HORSHAM DISTRICT COUNCIL CONSULTATION

TO:	Horsham District Council – Planning Dept
LOCATION:	Former Novartis Site Parsonage Road Horsham West Sussex
DESCRIPTION:	Residential development comprising approximately 206 dwellings, including the conversion of 'Building 3' and demolition of 'Building 36'. Vehicular access taken from Wimblehurst Road. Car and cycle parking, landscaping and open space and associated works. The replacement of the existing cedar trees at the site.
REFERENCE:	DC/25/0629
RECOMMENDATION:	Advice / more information / modification
2nd response in Red	Holding objection to RPA concerns that have not been addressed or appropriately justified and additional RPA concerns with proposed drainage infrastructure / more information / modification
3rd Response in Blue	Advice – previous concerns have been mostly addressed- subject to an Arboricultural Method Statement being secured by condition that sets out how sensitive works within RPAs of retained trees will be undertaken in accordance with the approved documents.

SUMMARY OF COMMENTS & RECOMMENDATION:

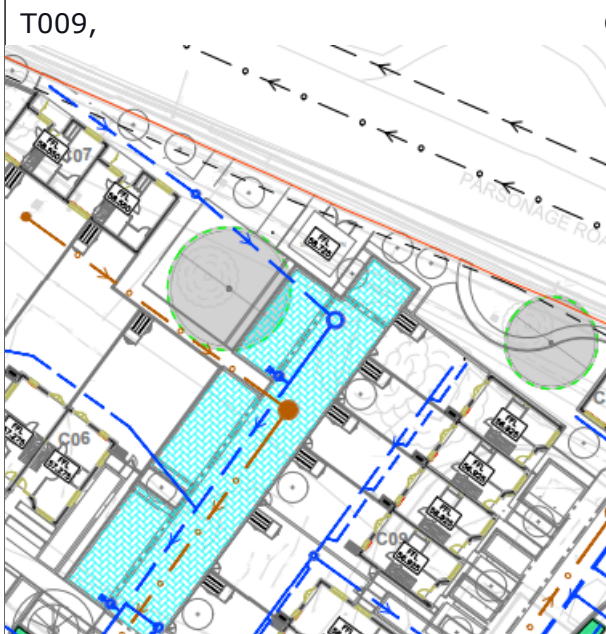
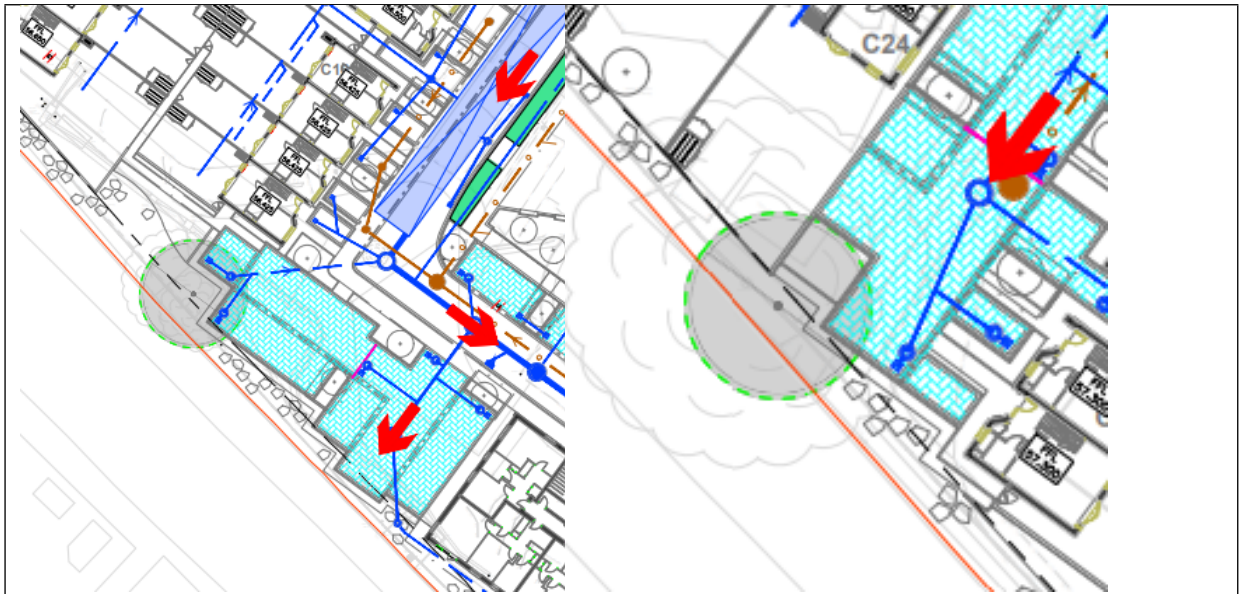
T002, T006, T007: Outbuildings erected using "no-dig" or base-and-beam foundations. The outbuildings, such as bike stores, should be moved and kept outside of the RPAs. **The bike stores still appear to be shown within the RPAs of trees T002, T006, and T007. Given the trees' visually prominent roadside locations and high landscape value, the bike stores should be relocated outside of the RPAs. Modification is required** – Concerns mostly address, whereby the bike stores have been moved with regards to trees T006 and T007, however it is felt that the bike stores in the RPA's of T002 and T004 should be relocated outside of RPAs.

T002, T004, T006, T007, T048: Fencing installed using Met-Posts to avoid digging; no concerns.
